EASA Position regarding FAA AD 2023-10-02 – Not eligible for adoption

[Docket No. FAA-2022-1647; Project Identifier AD-2022-01379-T; Amendment 39-22438; AD 2023-10-02]

Airworthiness Directives; Transport and Commuter Category Airplanes

Figure 1 to paragraph (g)(1)(i)— *Fundamental Effective Isotropic PSD at Outside Interface of Airplane Antenna*

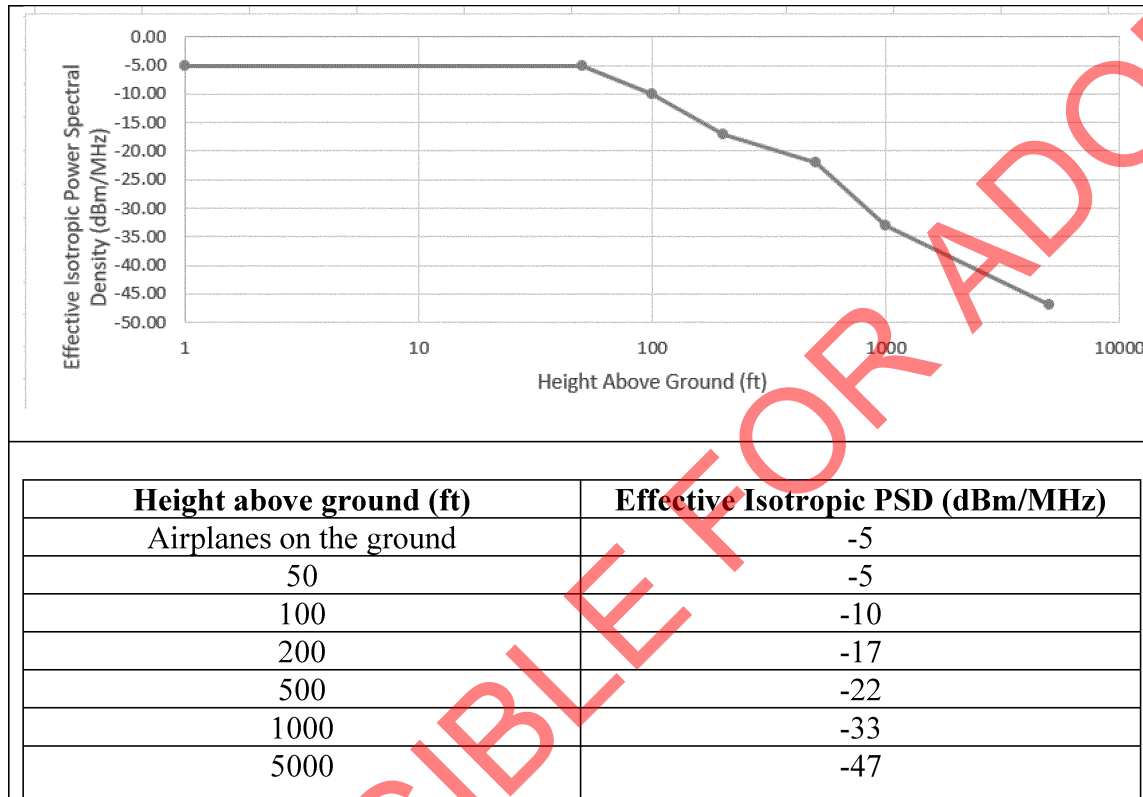
Comment summary: Textron Aviation requested the FAA clarify at what reference point the PSD requirements apply. The commenter stated it assumed that they apply at the radio altimeter receive antenna input, such that antenna characteristics, coax loss, and filter characteristics would be included in the determination.

Comment summary: Thales requested that the radio altimeter performance criteria specified in figure 1 to paragraph (g)(2) of the proposed AD be revised to explicitly cover any 5G emitter station up to 65 dB/MHz in the applicable 3.7–3.98 GHz band.

FAA response: The FAA agrees and has changed the title of figure 1 to paragraph (g)(1)(i) of this AD to reflect that the PSD requirements apply at the antenna input to the radio altimeter, and that the figure applies to the outward facing side of the antenna.

FAA response: The FAA agrees and has changed paragraphs (g)(1)(i) and (ii) of this AD to include the applicable frequency bands.

Figure 2 to paragraph (g)(1)(ii)— *Spurious Effective Isotropic PSD at Outside Interface of Airplane Antenna*

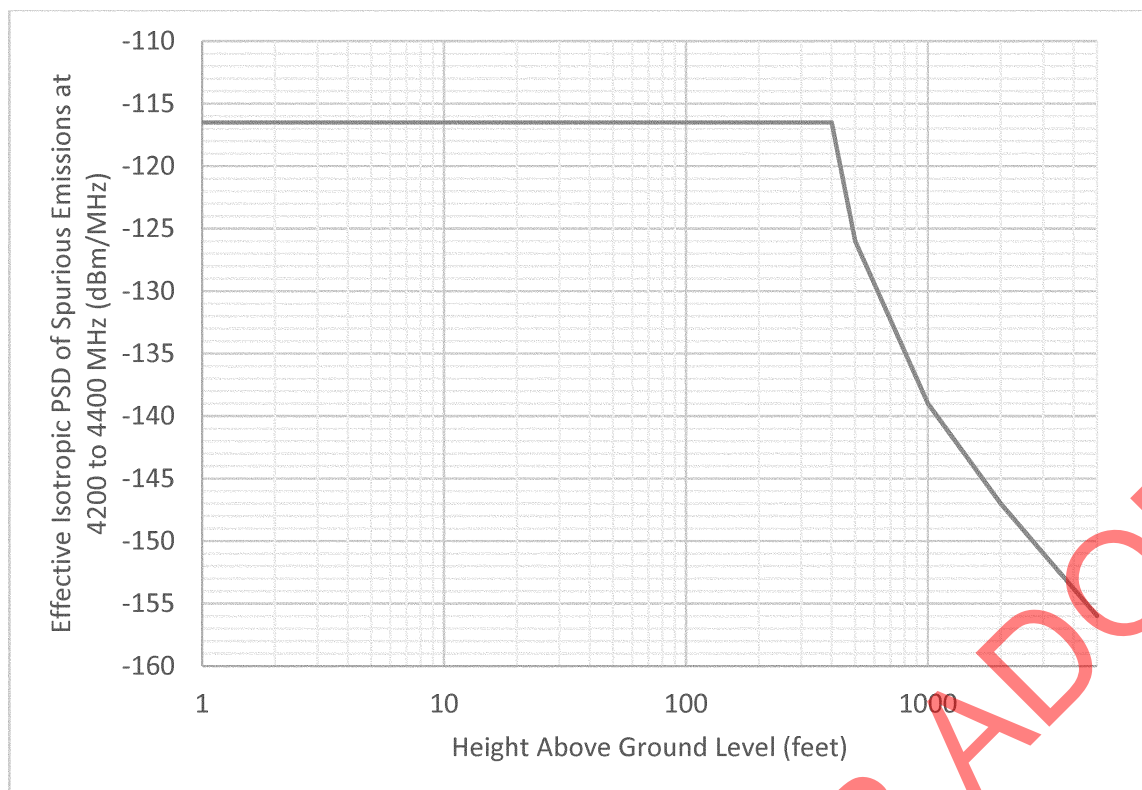
Comment summary: AIA requested that the FAA provide more information about the tolerances for determination of whether an airplane is radio altimeter tolerant. Several commenters requested that the FAA add a new figure indicating the spurious tolerance, similar to the figure with the PSD tolerance curve, and a specification of the altitude dependence for spurious tolerance.

Comment summary: Airbus and Bombardier requested that the FAA revise the table at the bottom of the proposed PSD curve to add the limit for 2500 feet above ground level. The commenters stated that

this would be consistent with the maximum operating range of popular radio altimeter models installed on many airplanes and would avoid extrapolation errors.

FAA response: The FAA agrees and has replaced the proposed fixed emission level with a spurious PSD tolerance curve in figure 2 to paragraph (g)(1)(ii) of this AD. Subsequent figures have been redesignated accordingly.

FAA response: The FAA disagrees. The FAA developed the PSD curve to cover all transport and commuter radio altimeters and has determined that any extrapolation errors are sufficiently small and will not affect compliance or compromise safety.
